ASSESSMENT REPORT

PROPOSED MODIFICATION - CAMDEN GAS PROJECT

Figure 1 – GL15 SIS Well Location

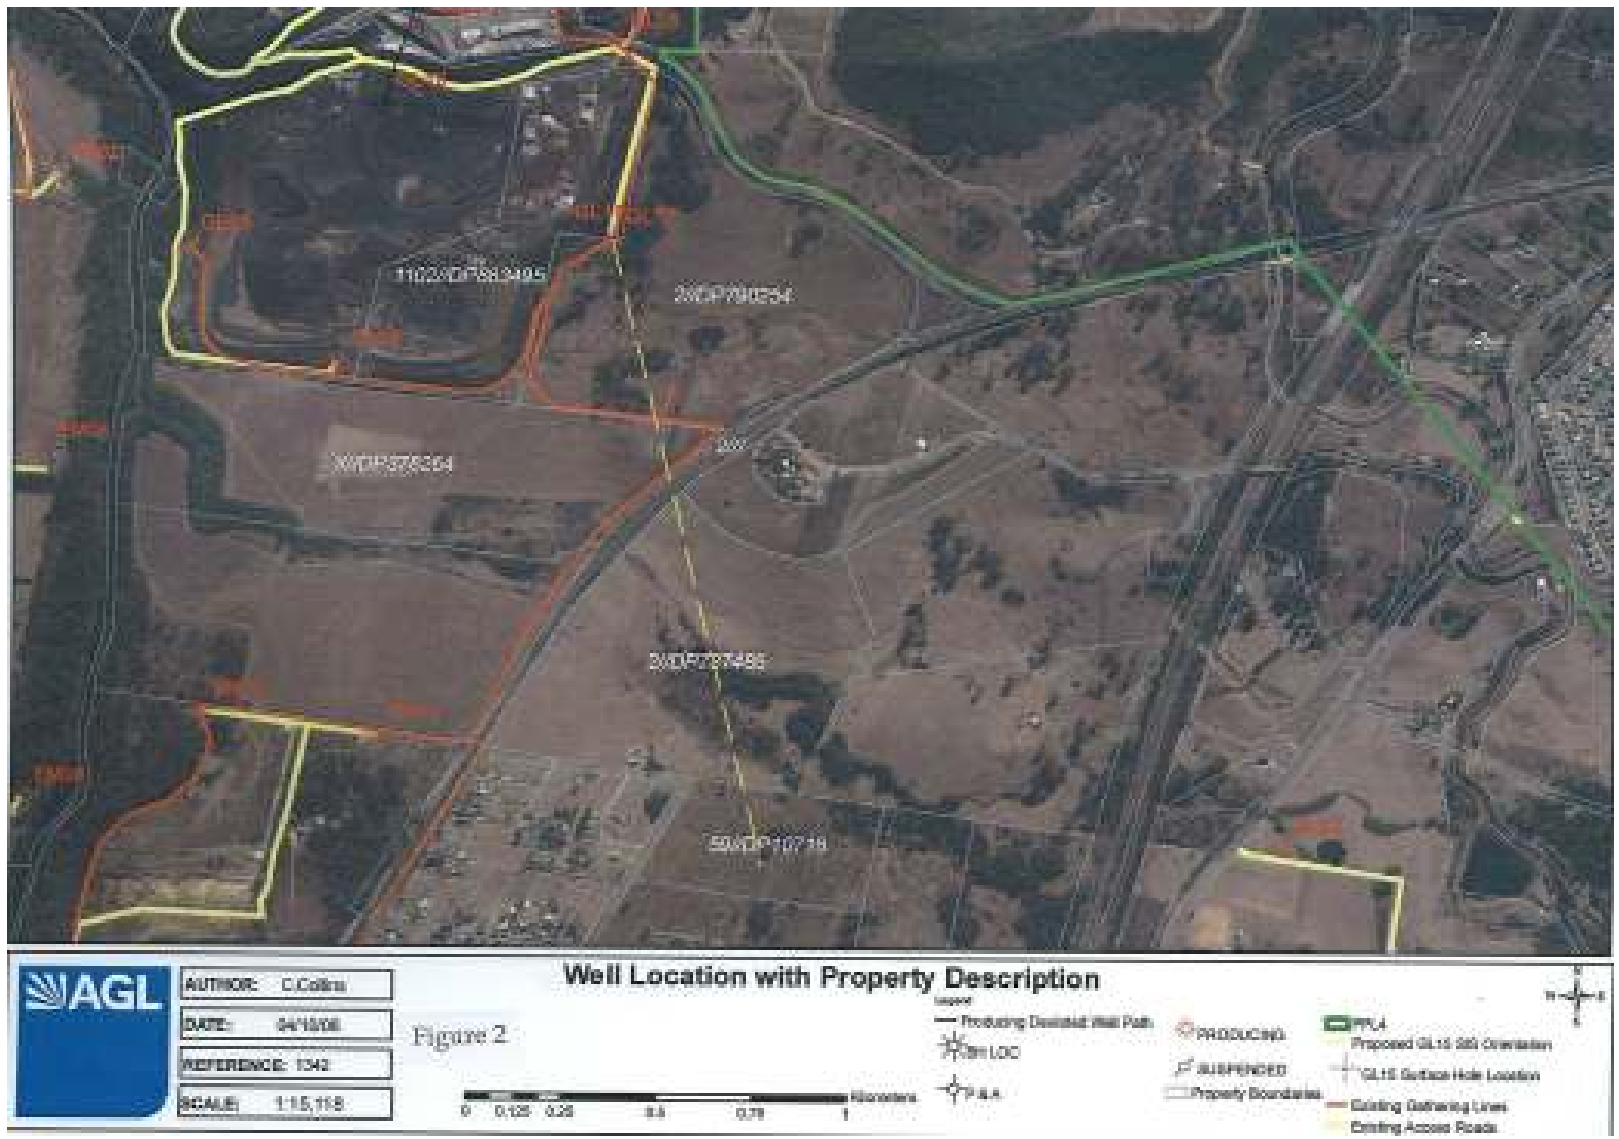
The proposed SIS well would follow the drill path of the approved directional well from the GL10 well pad until it intersects with the coal seam at a depth of approximately 700-800m. A smaller-diameter hole would then be drilled entering the coal seam at 90 degrees to the seam for a distance of about 1500m. There are no surface works along the drill path. The proposed SIS well drill path and in-seam path are illustrated in Figure 1.

- (a) is satisfied that the proposal is substantially the same development for which consent was originally granted, being the development of gas wells for the production of coal seam methane gas. The only differences between the approved directional well and the proposed SIS well are the length of the drill hole and the construction method. These differences are considered to be minor and do not substantially change the nature and scale of the Camden Gas Project;
